UNITED STATES PATENT AND TRADEMARK OFFICE

APPLICATION NO.	FILING DATE	FIRST NAMED INVENTOR	ATTORNEY DOCKET NO.	CONFIRMATION NO.
10/646,611	08/22/2003	Guy Simon Dawson	37261P087	9810

Office Action Summary	Application No. 10/646,611	Applicant(s) DAWSON, GUY SIMON	
	Examiner Vinh T Luong	Art Unit 3682

ATTACHMENT

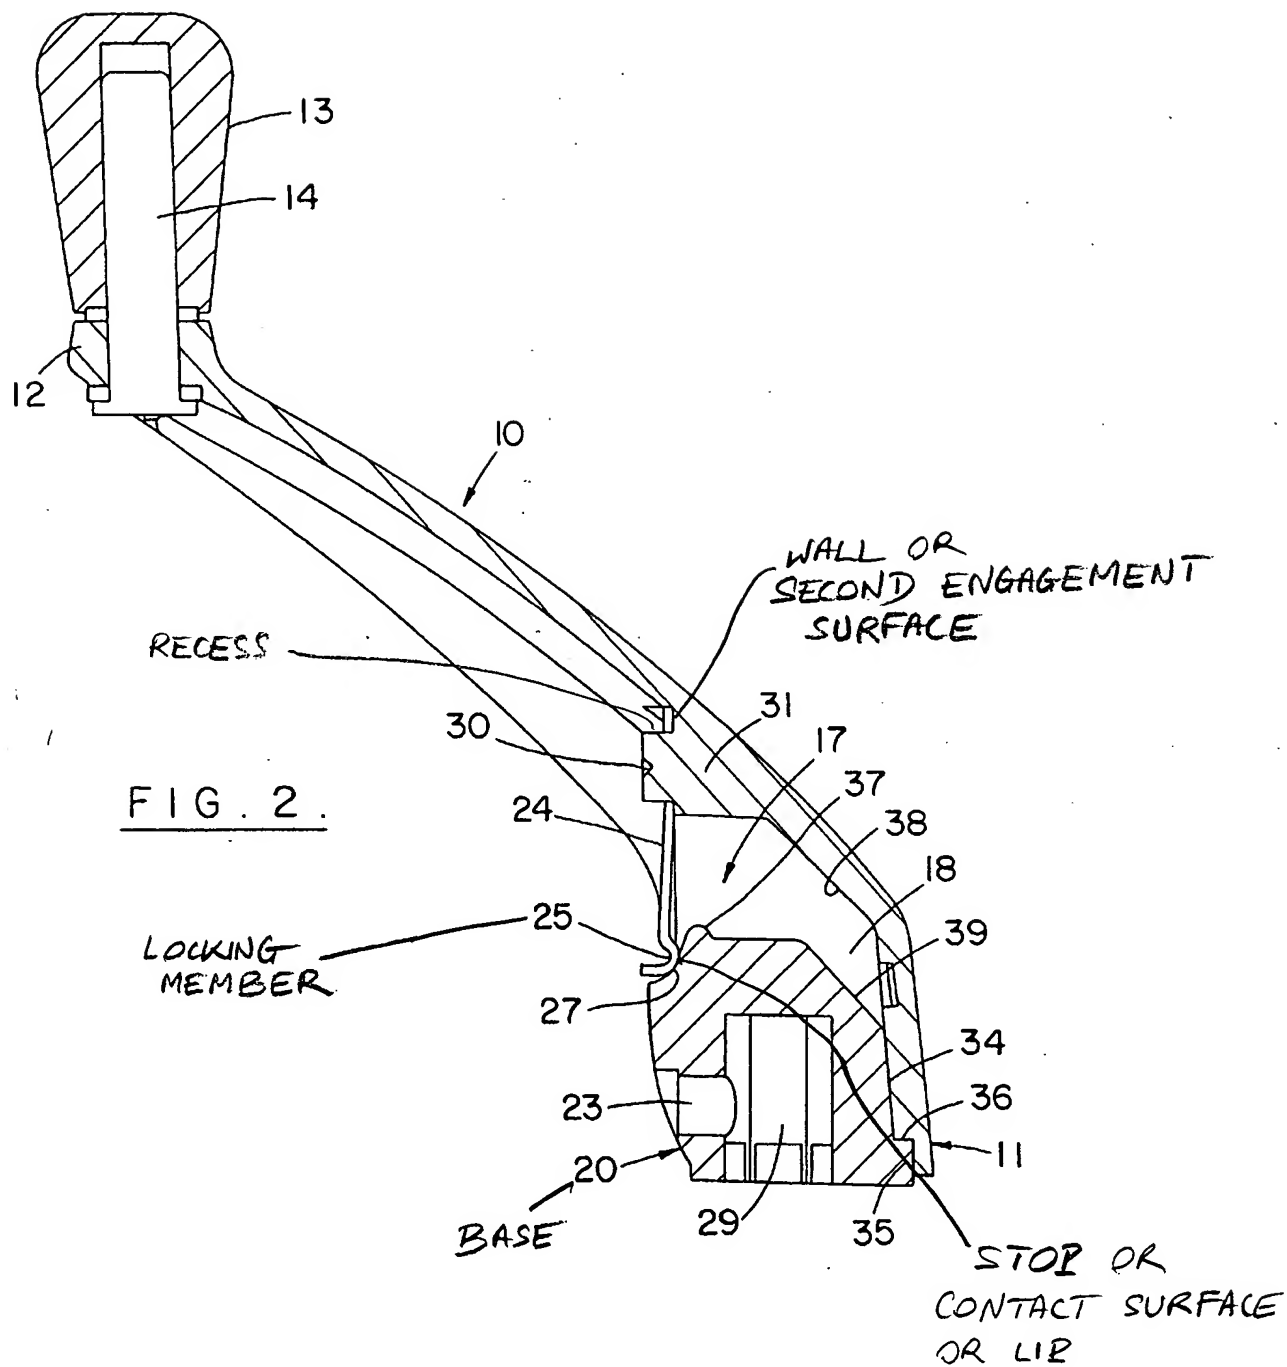
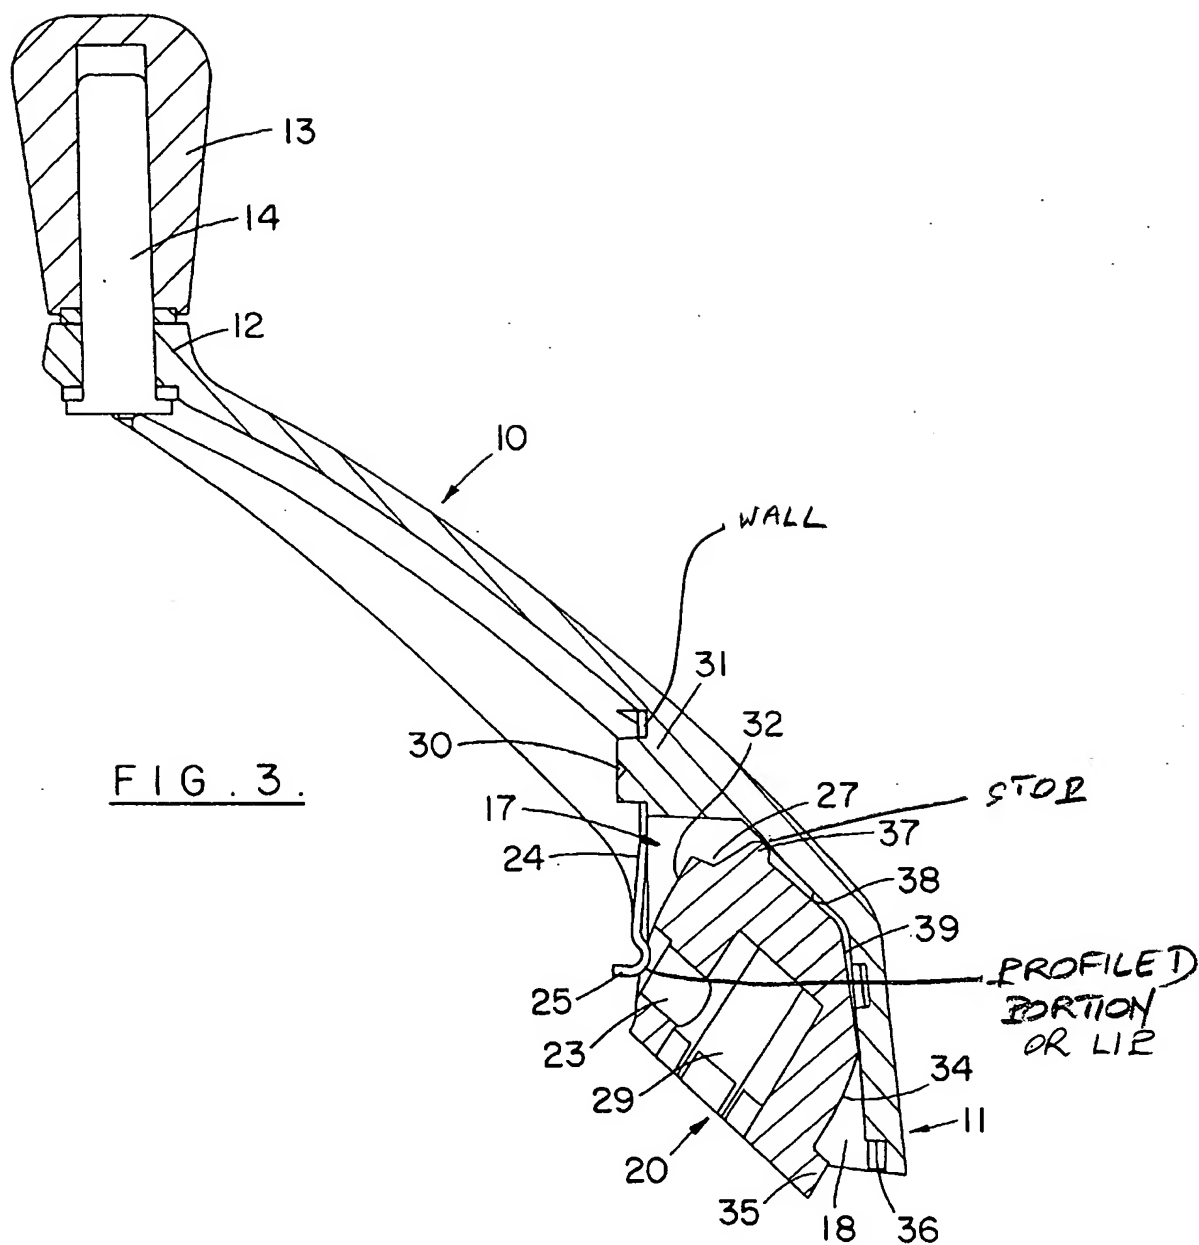
Regarding claim 2, the push button 24 includes a head (see Attachment, Fig. 1) which is slidably located in a recess (Fig. 2, Att.) the handle member 10.

Regarding claim 3, the peripheral shape of the recess (Fig. 2, Att.) substantially corresponds to the peripheral shape of the button 24.

Regarding claim 7, see a stop 25 (Fig. 2, Att.) to prevent movement of the locking member 25 under action of the biasing mechanism 24 from moving beyond the locking position (Fig. 2). *Ibid.*, col. 3, lines 7-25. Alternatively, see a stop 37 (Fig. 3) to prevent movement of the locking member 25 under action of the biasing mechanism 24 from moving beyond the locking position.

Regarding claim 10, the locking member 25 includes a profiled portion 25 (Att.) which provides a clearance (at 23 in Fig. 3) between the locking portion 25 and the pivot base 20 when the locking member 25 is in the release position (Fig. 3).

Regarding claim 11, the profiled portion 25 includes a contact surface (Att.) which contacts a profiled surface 27, 28 of the pivot base 20 during movement of the handle between the first and second positions (Figs. 2 and 3).

Regarding claim 13, the recess (Fig. 2, Att.) includes a contact surface 30 which is contacted by the head (Fig. 1, Att.) when the locking member 25 is in the release position.

Regarding claim 18, the lip 25 projects from the locking portion 25. The engagement surface 30 is formed by a wall (Att., Figs. 2 and 3) in the handle member 10. The wall (Att.) further forms a second engagement surface (Att.). The locking portion 25 of the locking member 25 is located between second engagement surface (Att.) and the pivot base 20 to create the blocking action.
